Subject: Borel Middle School HVAC Replacement
San Mateo - Foster City School District
Aedis Project No. 2021005
DSA Application #01-119557

ADDENDUM NO. 1

SHEET
 REF. SHEET MP2.05
AD1-MP2.05b

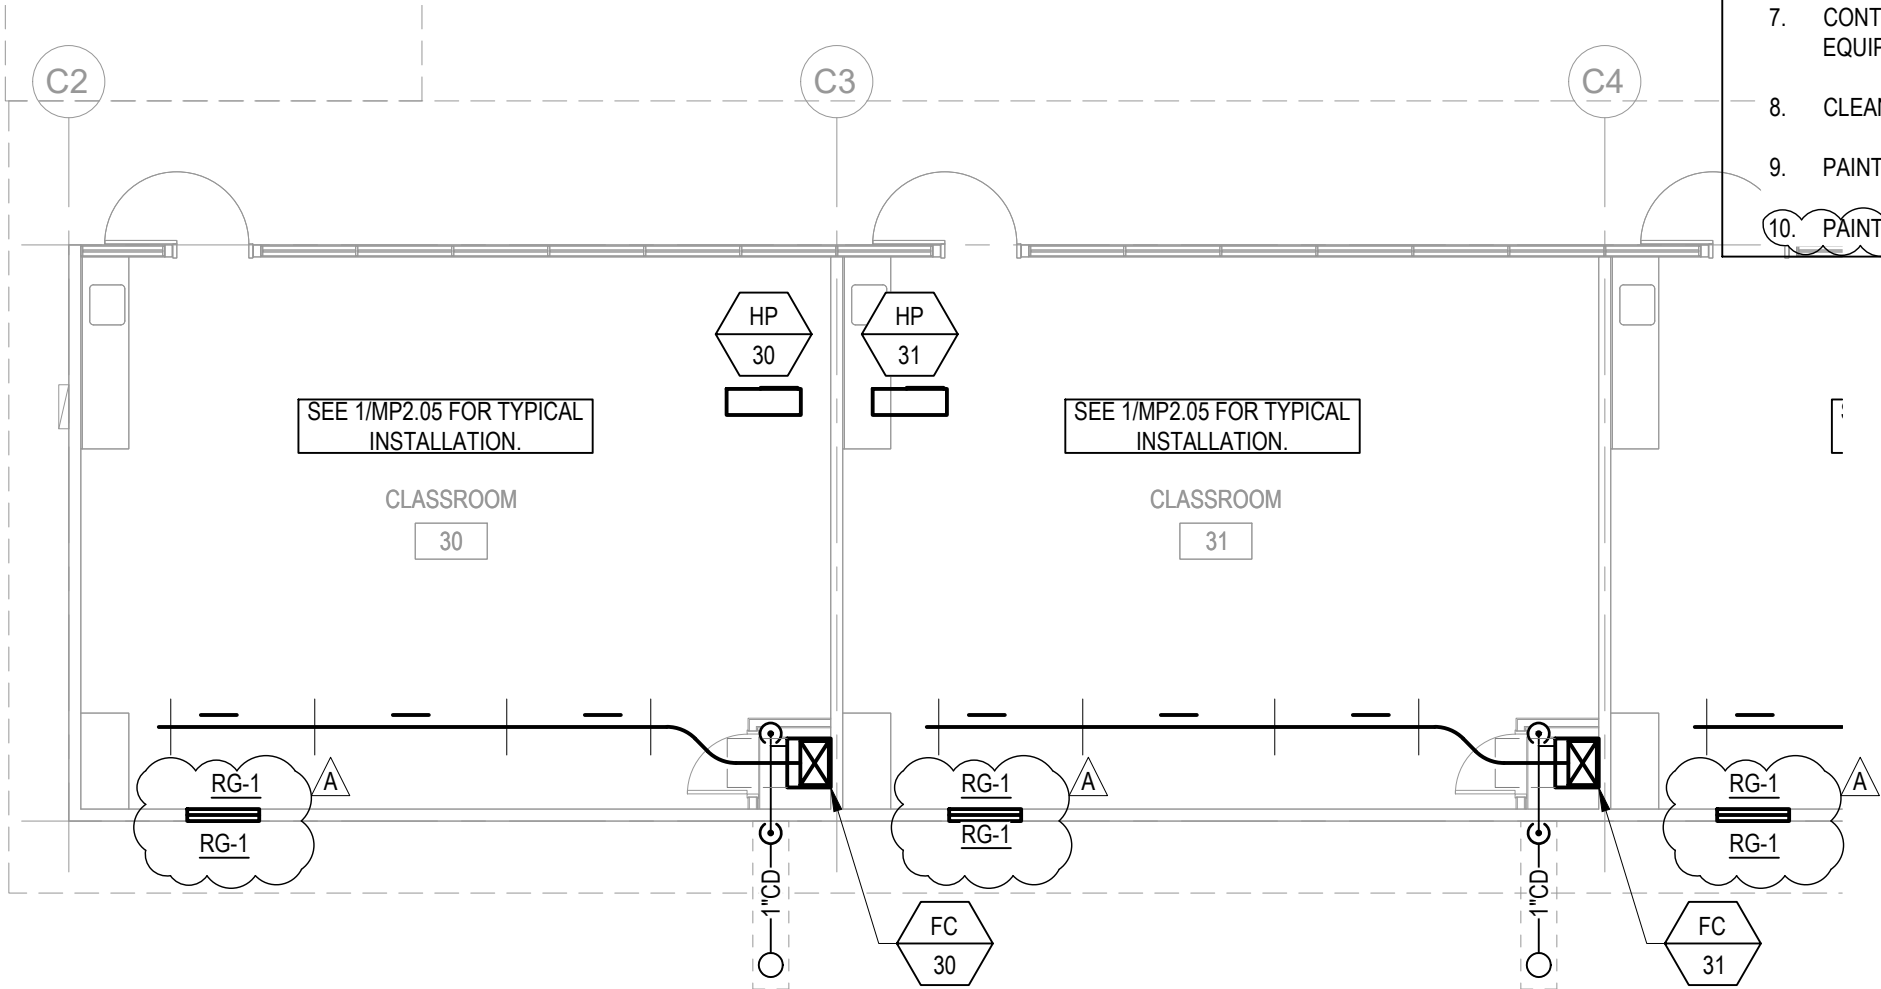
Revise: Keynote per AD1-MP2.05b.

AD1-MP2.06a

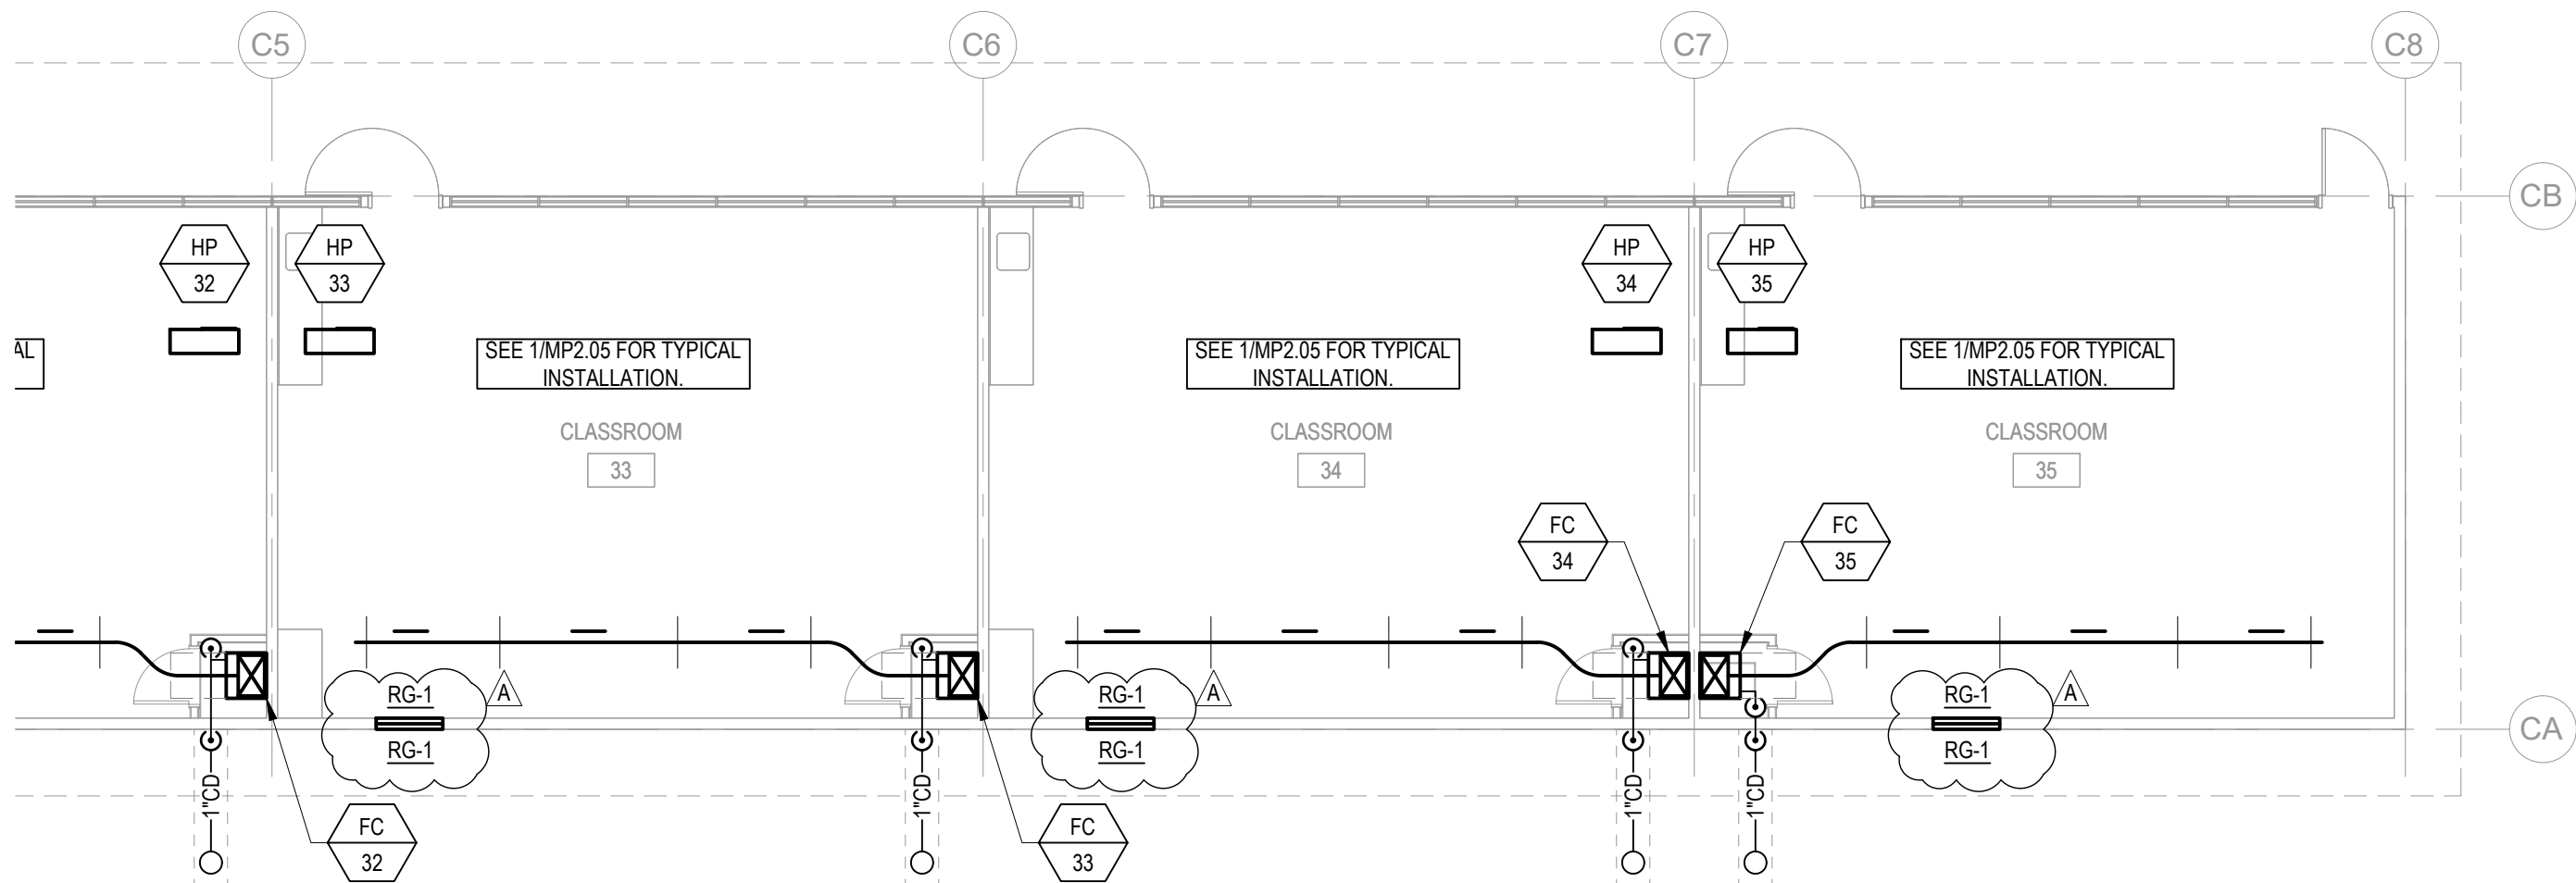
Revise: General Note #5 per AD1-MP2.06a

Add: General Note #10 per AD1-MP2.06a

Revise: Location of RG-1 per AD1-MP2.06a

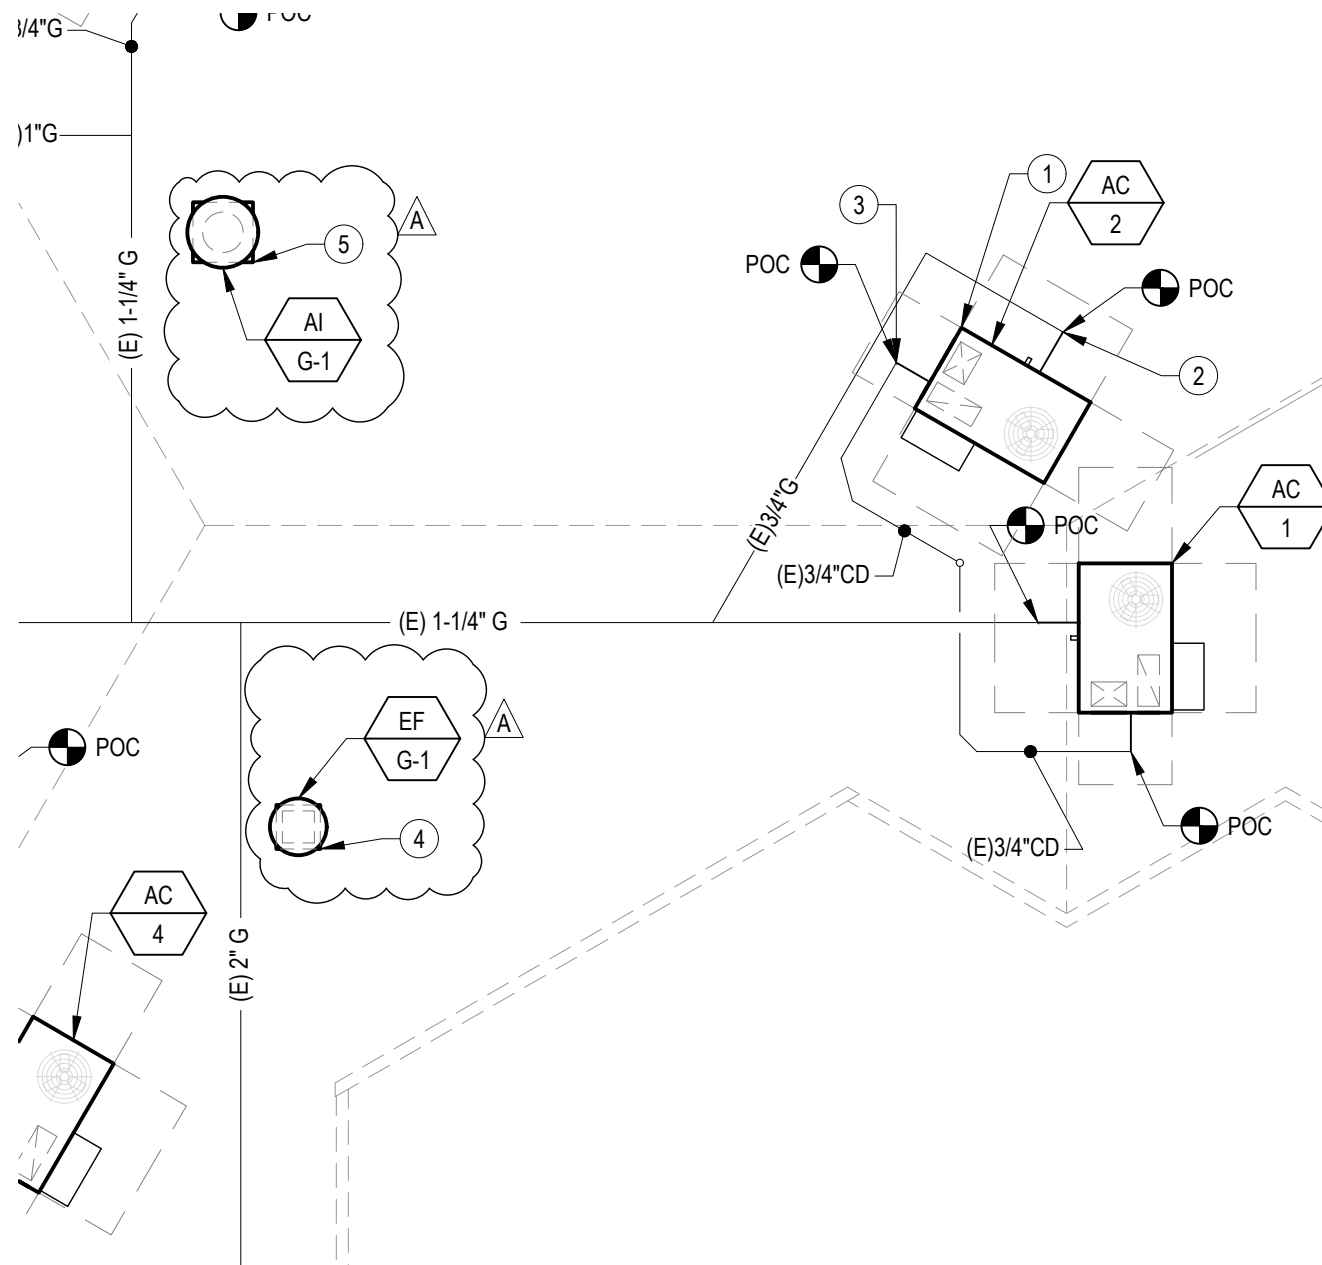
Revise: Location of RG-1 per AD1-MP2.06b

AD1-MP2.07

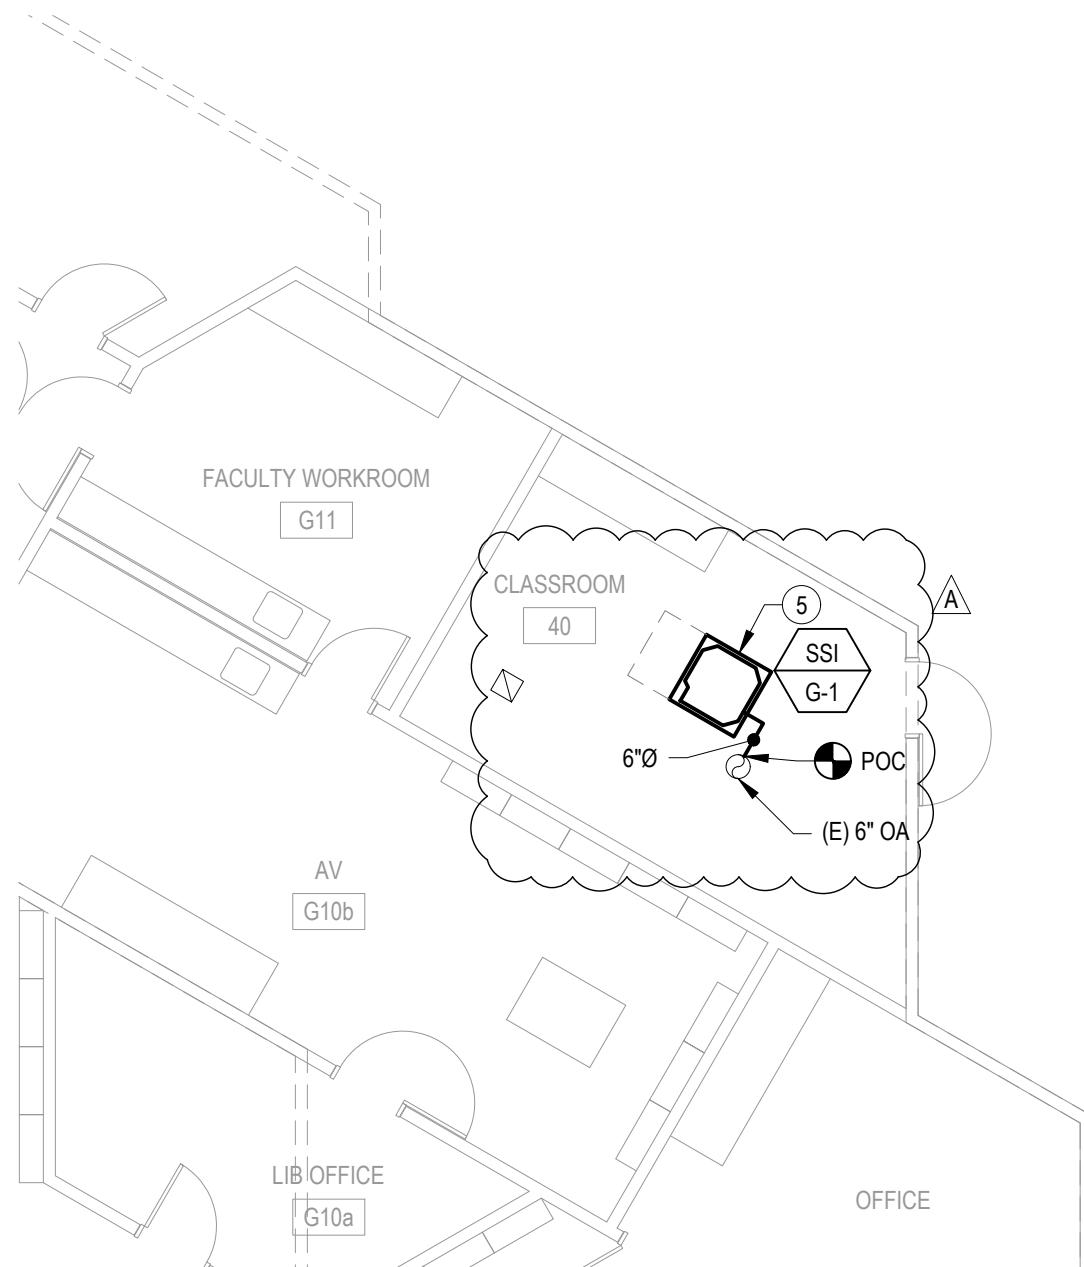
Add: Exhaust Fan per AD1-MP2.07

Add: Roof Hood per AD1-MP2.07

Revise: General Note #5 per AD1-MP2.07

Revise: New Sheet Note #1 per AD1-MP2.07

Add: New Sheet Notes #4 and 5 per AD1-MP2.07

BOREL MIDDLE SCHOOL - HVAC REPLACEMENT	
		SAN MATEO-FOSTER CITY SCHOOL DISTRICT	
387 S. 1st Street, Suite 300 San Jose, CA., 95113	tel: (408) 300 - 5160 fax: (408) 300 - 5121	FILE NO.: 41-26	SHEET
		APPL NO.: 01-119557	REF. SHEET MP2.08
		JOB NO. 2021005.07	AD1-MP2.08
		DATE 11/24/2021

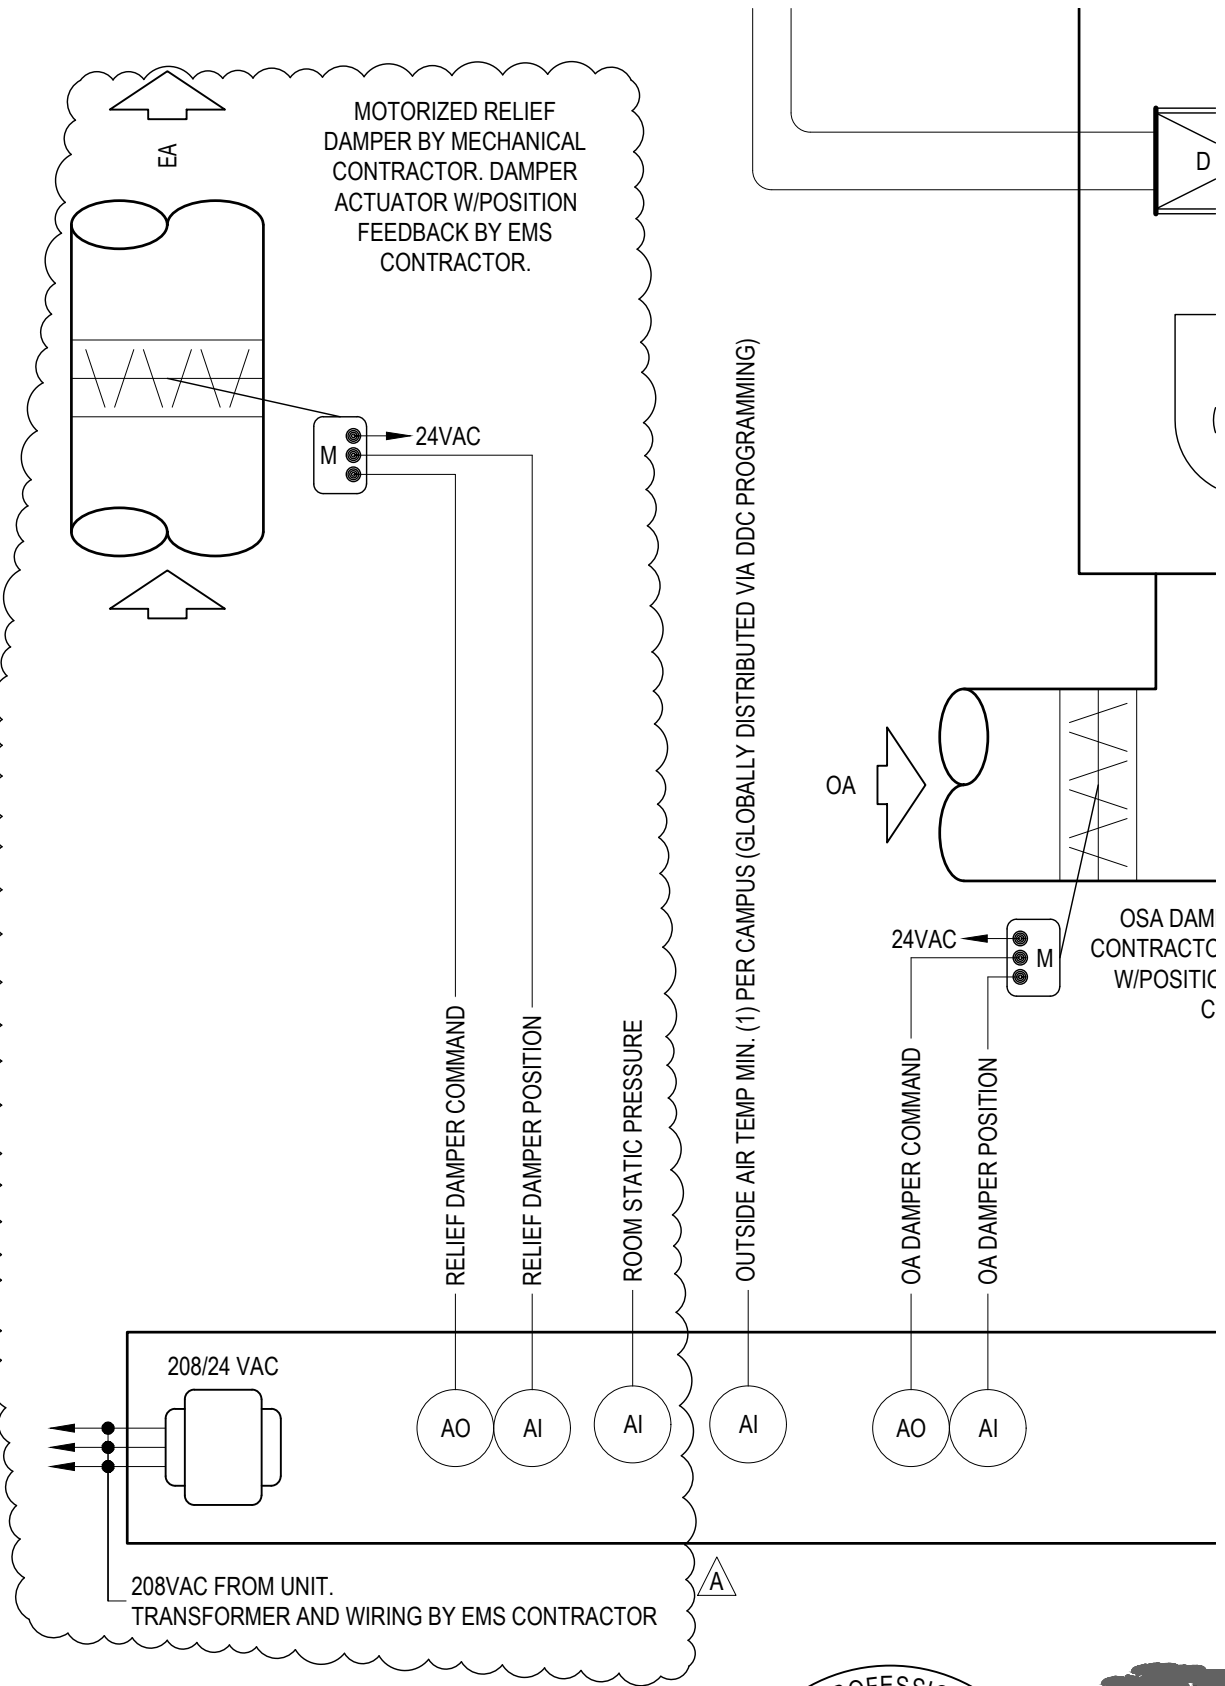
Add: Existing outside duct per AD1-MP2.08

Add: Existing return register per AD1-MP2.08

Revise: New Sheet Notes #5 per AD1-MP2.08

SHEET
REF. SHEET MP5.01
AD1-MP5.01

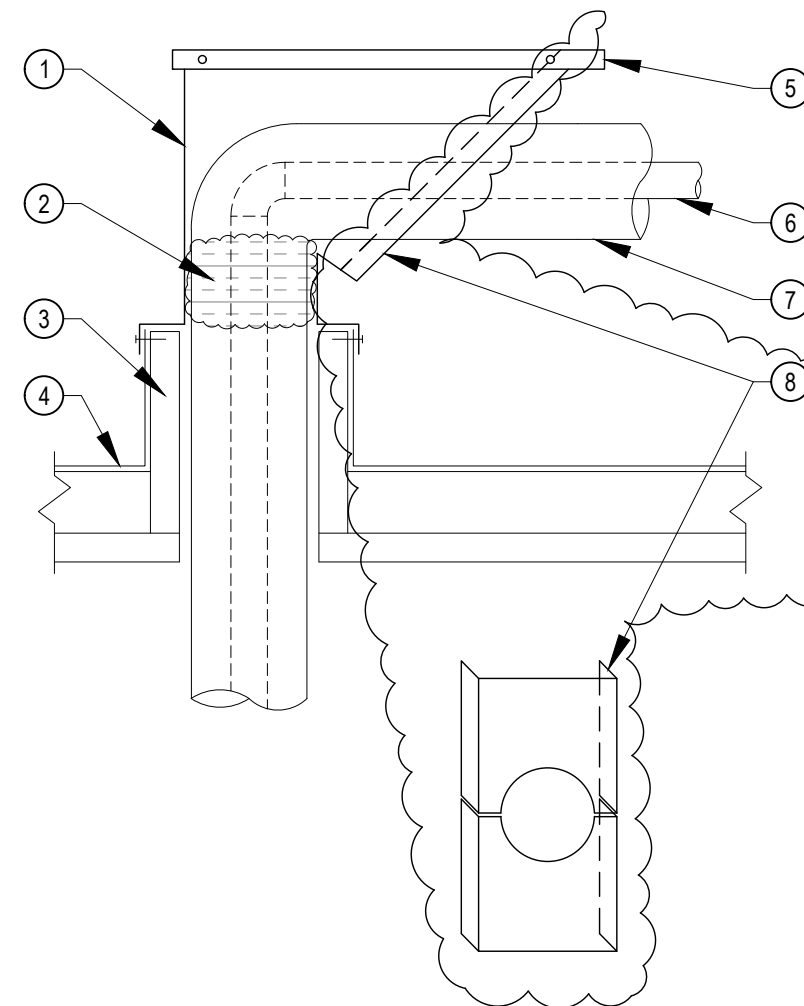
Revise: Classroom Split System Heat Pump / Fan Coil unit Control Schematic per
AD1-MP5.01
